**EXHIBIT I – GMP AMENDMENT**  
**GMP AMENDMENT TO AGREEMENT BETWEEN OWNER**  
**AND CONSTRUCTION MANAGER AT RISK FOR NORTH COUNTY SERVICE CENTER**  
**AGREEMENT NO. 21-0750-CMAR**

**CREATIVE CONTRACTORS, INC.**  
**North County Service Center**  
 Revised 2/9/26  
**GMP w/addendum #7**  
**PROJECT COST SUMMARY**

**REQUEST FOR INFORMATION LOG**  
**North County Service Center**  
**Clearwater, FL**

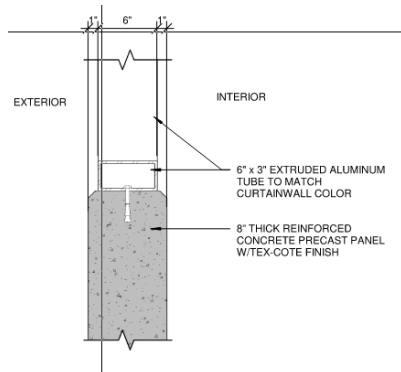
Sheet AG15-3 details the Hendricks aluminum tubes that are to go on the first and second floor of the parking garage. There will be no way to bolt it into the precast panel without putting a hole in to the top of the frame. Please advise if there are any alternative details we can use.

The second-floor aluminum frame details will be revised to show the anchor counter-sunk at surface coming in from outside of the frame, similar to the first-floor perforated panel details. Only the first-floor system is a Hendrick product, the second-floor details show generic aluminum framing by YKK.

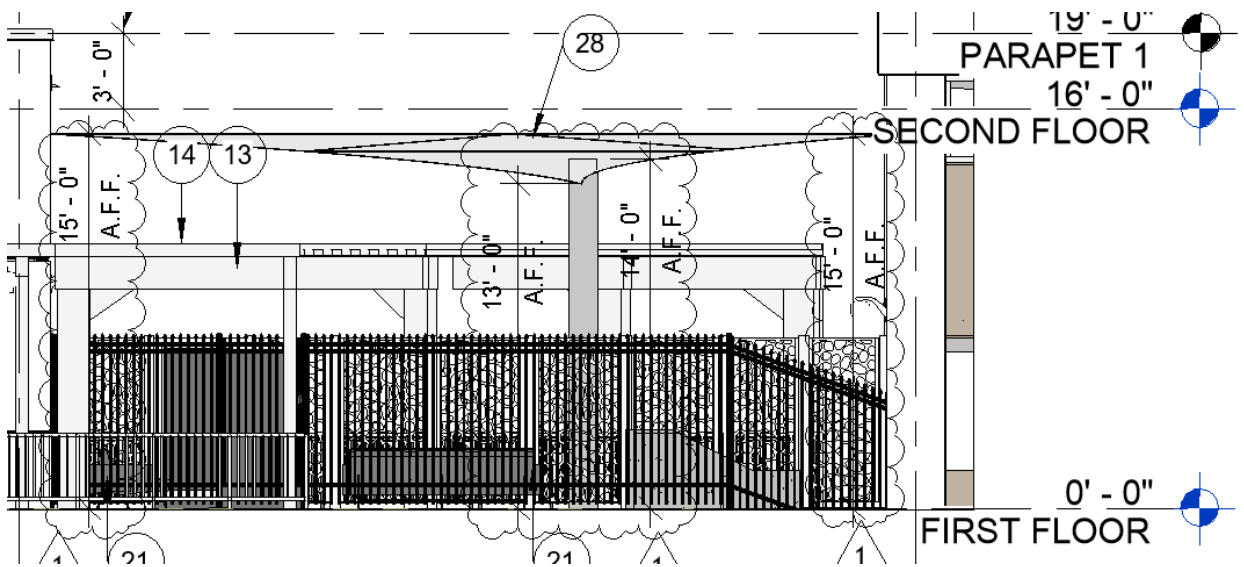
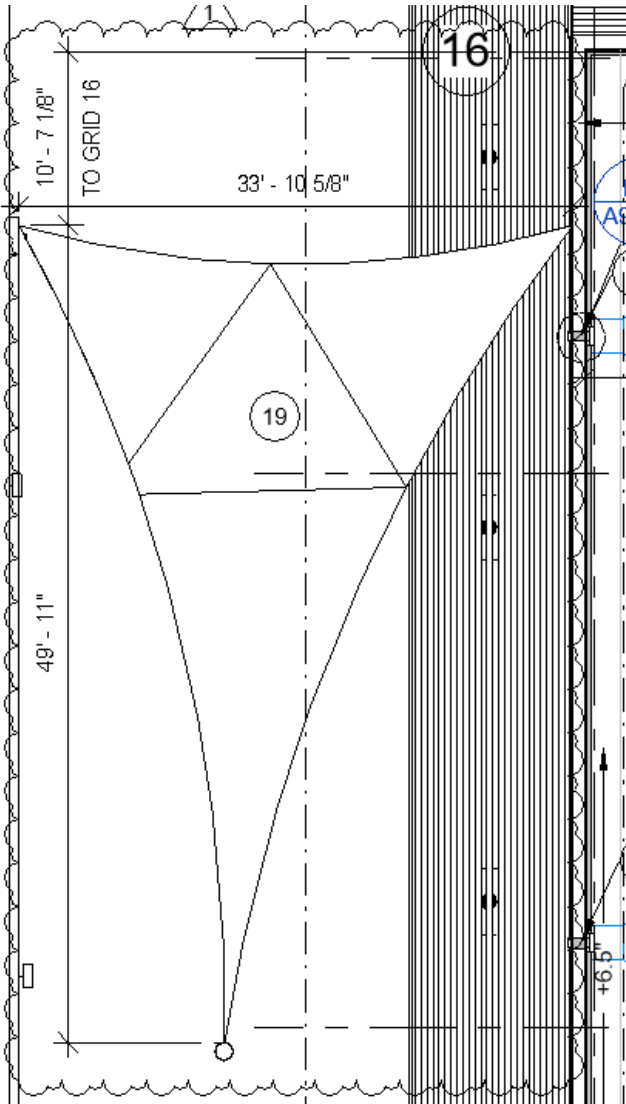
<b>QUESTION:</b>	
The finish schedule on sheet ID5-1, ID5-2, and ID5-3 has two different types of "VC1". Please advise which one is to be used.	
<b>DATE:</b>	3/17/25

<b>ANSWER:</b>	
The correct one is the Johnsonite 63 Burnt Umber. Shari Bennett	
<b>DATE:</b>	3/19/25
